**INFORMAL GROUP ON GASEOUS FUEL VEHICLES**  
**Within the UN GRPE (WP29)**  
**PROPOSED AMENDMENT GFV-02-04**

**Regulation name and reference number:** Regulation 115

Proposals for Draft Amendment and Comments to Regulation 115

**Table 3**

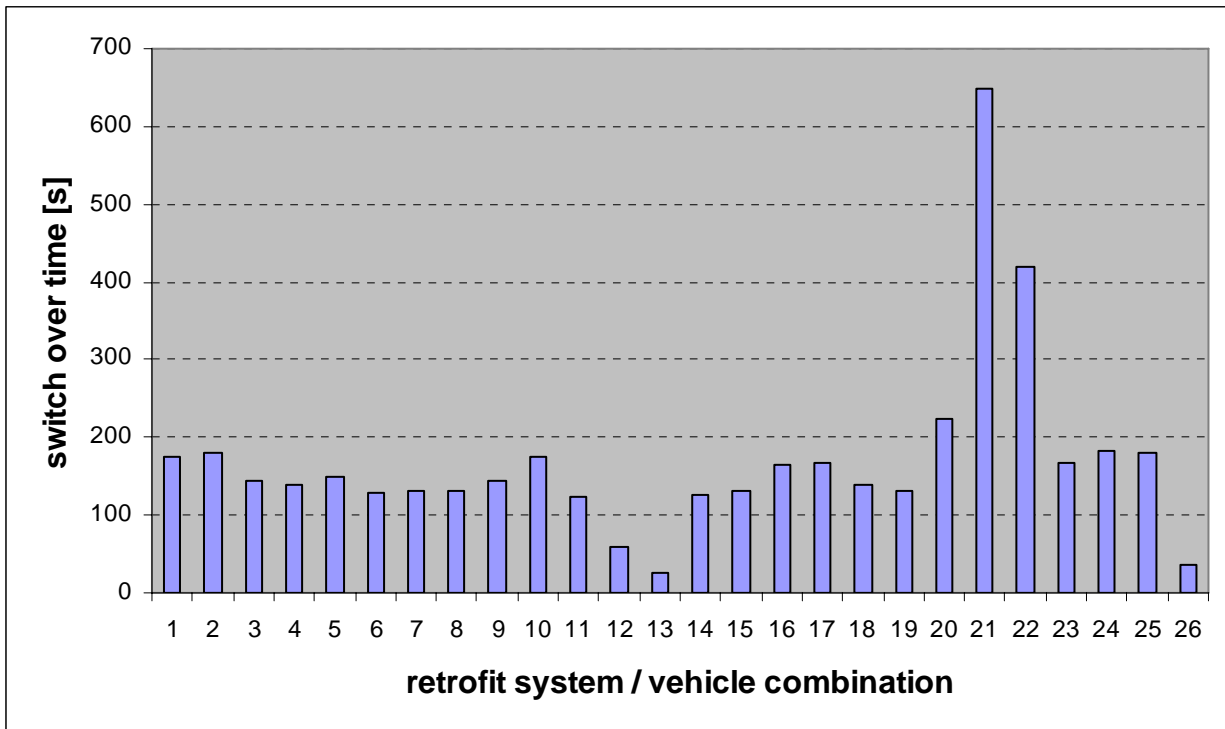
(vi) The introduction of the “non-intrusive” concept leads to the situation that the emission limit values for the “intrusive” and “non-intrusive” systems are different which should not be acceptable. Consequently, the limit values are not performance-oriented, but are design-oriented. The difference between the emission limit values for “intrusive” and “non-intrusive” systems is shown in Table 3 below.

**Fig. 1. Switch over time for some retrofit system/vehicle combinations**  
 (Source: Environmental Protection Division, Motor Transport Institute, Warsaw, Poland)

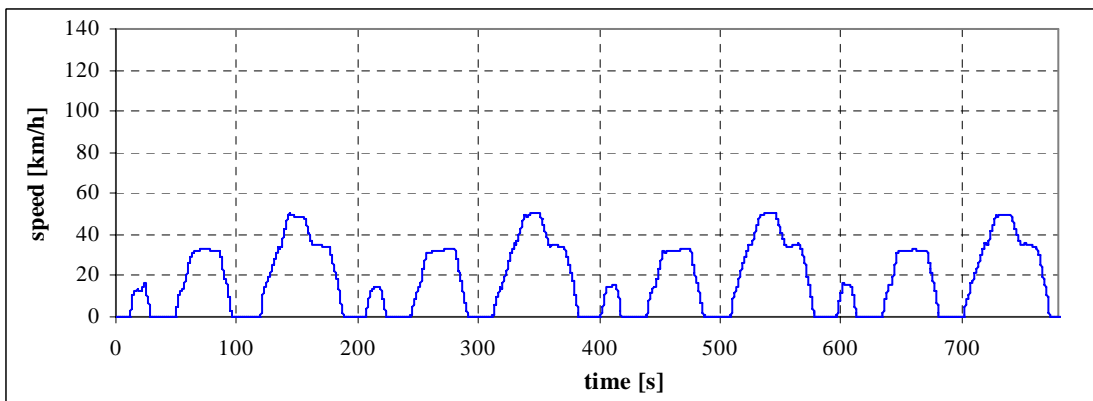
(vii) In LPG mode the switch over from petrol fuelling to LPG fuelling in the type 1 test occurs after some time. The switch over time of some retrofit system/vehicle combinations submitted for the type-approval in Poland is shown in Figure 1.

This switch over time varies from 25 s to 648 s. It seems that this time in some retrofit systems is made longer than required to reduce the emission in LPG mode in the type 1 test and consequently to make it possible to comply with the requirements in force.

**Fig. 2. Relative emission versus time for vehicle A in the urban part of the type 1 test**  
 (Source: Environmental Protection Division, Motor Transport Institute, Warsaw, Poland)

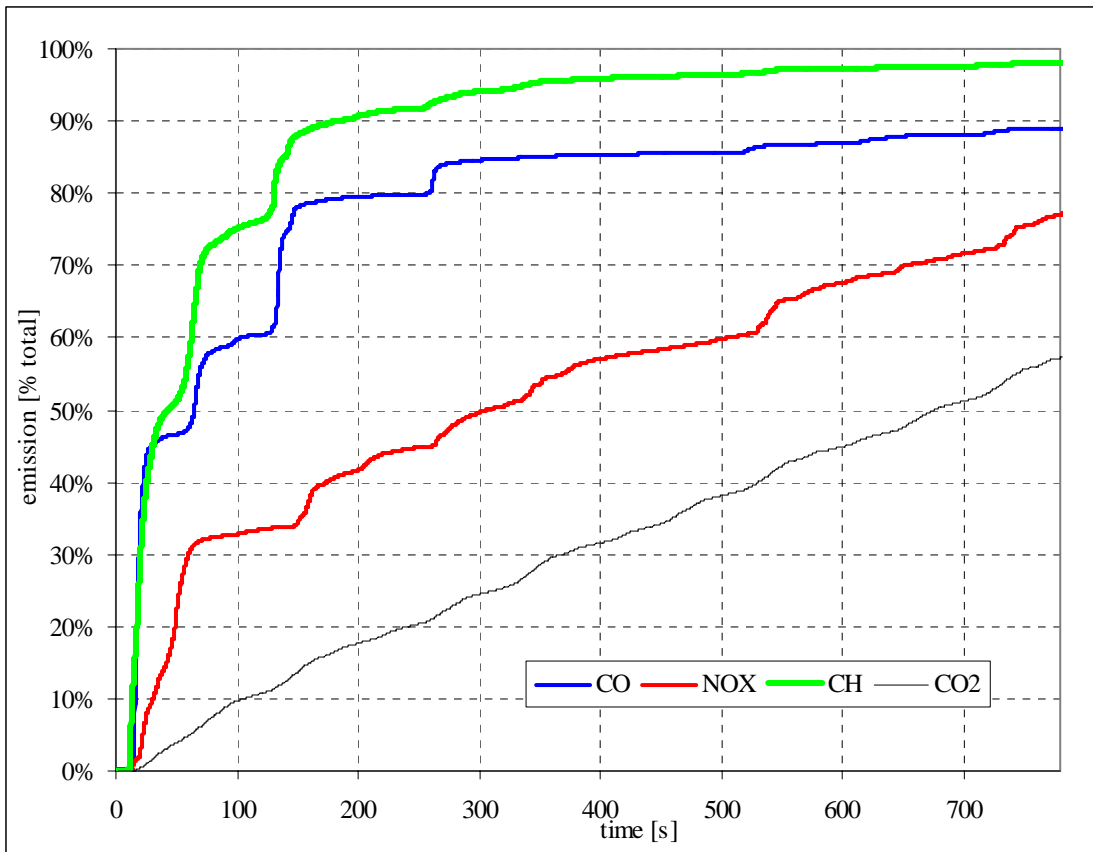
Figures 2 and 3 show the relative emission in the urban cycle (the total value measured over the whole type 1 test = 100%) versus time for 2 vehicles converted to LPG. Such curves are typical for Euro 3 and Euro 4 vehicles.

**Fig. 3. Relative emission versus time for vehicle B in the urban part of the type 1 test** (Source: Environmental Protection Division, Motor Transport Institute, Warsaw, Poland) Based on Figures 2 and 3

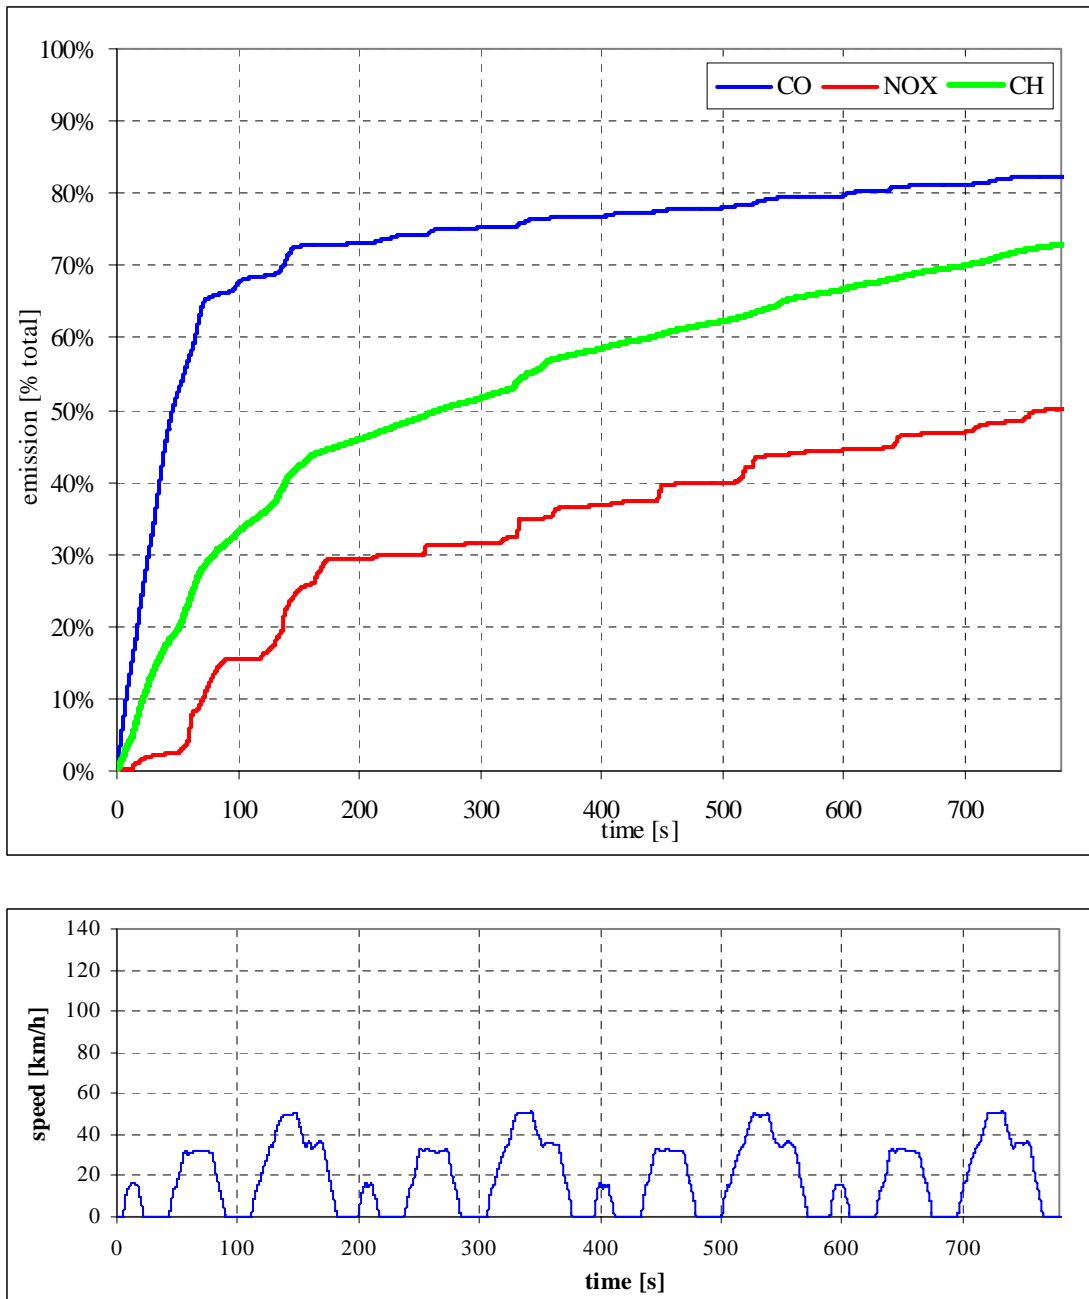
the ratio of the emission with LPG in LPG mode determined on the assumption that the total emission in the type 1 test is equal to the limit divided by the emission with petrol in petrol mode in the period equivalent to the operation with LPG in LPG mode (referred to as "LPG/petrol emission ratio" hereinafter)

**Fig. 4. LPG/petrol emission ratio for different ratio of actual emission with petrol to limit (40%, 60% 80%, 100%) for “non-intrusive” retrofit system**

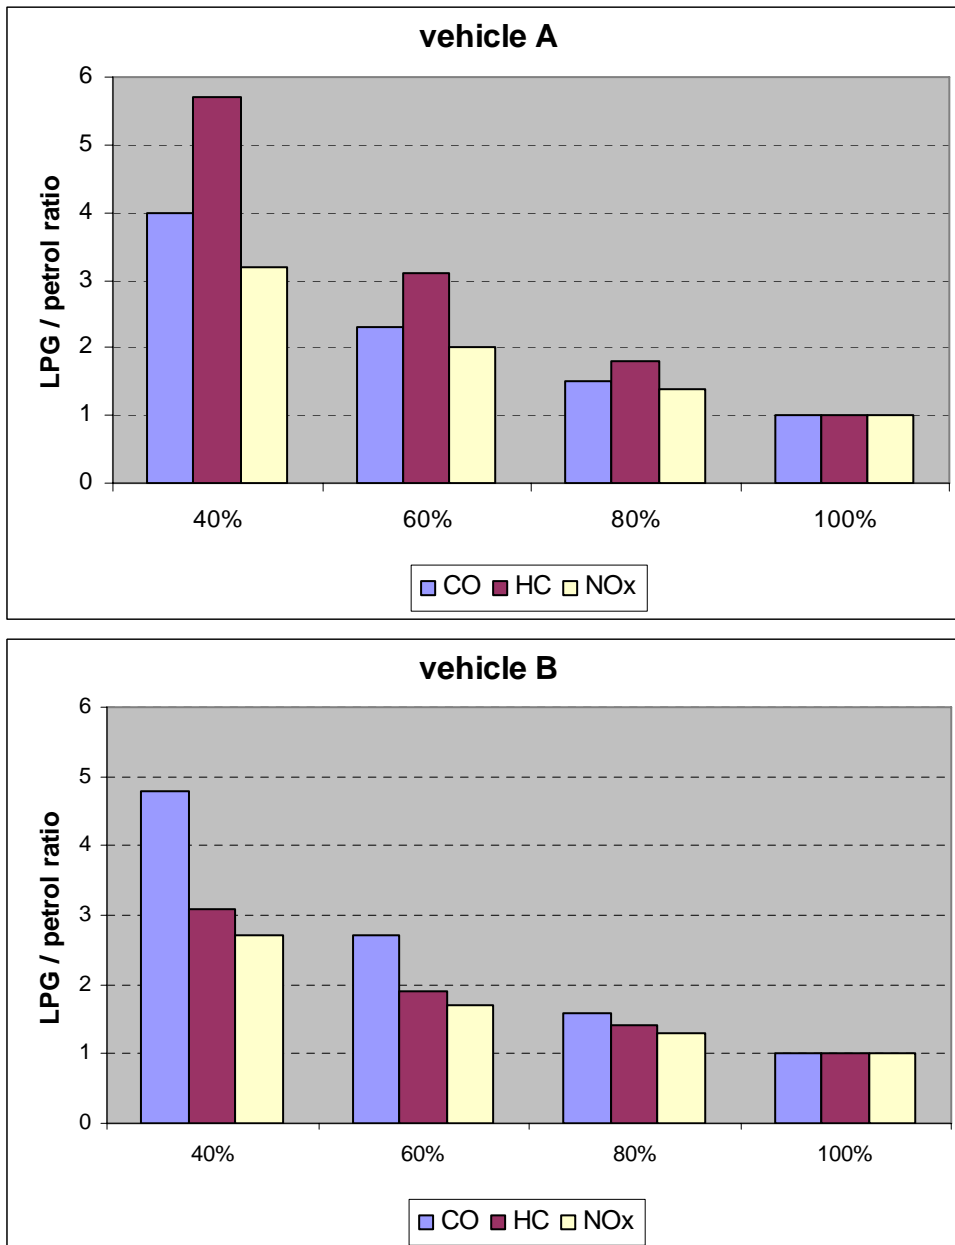
The LPG/petrol emission ratio is shown in Figure 4.

The ratio of the actual emission to the limit value is usually in the order of 40% - 60% for Euro 3 and Euro 4 vehicles. If it is equal to 40%, the relative emission versus time curve is similar to those shown in Figures 2 and 3 and the switch over time is 60 s, the emission with LPG may be even about 5 times higher than that with petrol and the vehicle is deemed to comply with the requirements of Regulation 115 for “non-intrusive” retrofit systems.

**Fig. 5. LPG/petrol emission ration versus switch over time for different ratio of actual emission with petrol to limit (40%, 60% 80%, 100%) for “non-intrusive” retrofit system (HC, vehicle A)**

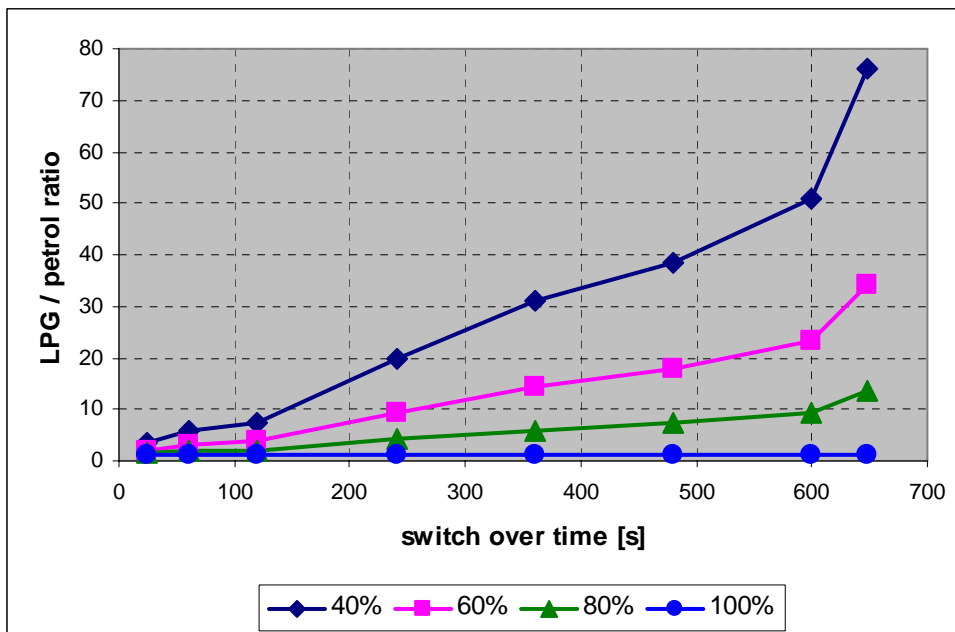
Figure 5 shows the effect of the switch over time on the LPG/petrol emission ratio for HC (vehicle A).

In Figure 5 the switch over time varies from 25 s (the shortest time in Figure 1) to 648 s (the longest time in Figure 1). If the ratio of the actual emission to the limit value is 40 %, the switch over time is 648 s and the relative emission versus time curve is similar to that shown in Figures 2, **the emission with LPG may be even 70 times higher than that with petrol and the vehicle is deemed to comply with the requirements of Regulation 115 for “non-intrusive” retrofit systems.** Even when the switch over time is 25 s, the emission with LPG may be 3 times higher.

LPG is believed to be a “clean” fuel. It has several features that can contribute to the reduction of emission. However they are not taken advantage of in the current Regulation 115. The emission with LPG may be several, in extreme case even more than 70, times higher than that with petrol (Figure 5) and the system passes the tests.

(i) The following paragraphs should be deleted:

- 2.1.5,
- 3.2.5,
- 5.2,
- 6.1.2.2,
- 6.1.2.5.1.4,
- 6.1.2.5.1.4.1,
- 6.1.2.5.1.4.2,
- 6.1.2.5.3.4,

- 6.1.3.4,
- Annex 1A, item 11.1, the second line,
- Annex 3A, item 2.4.
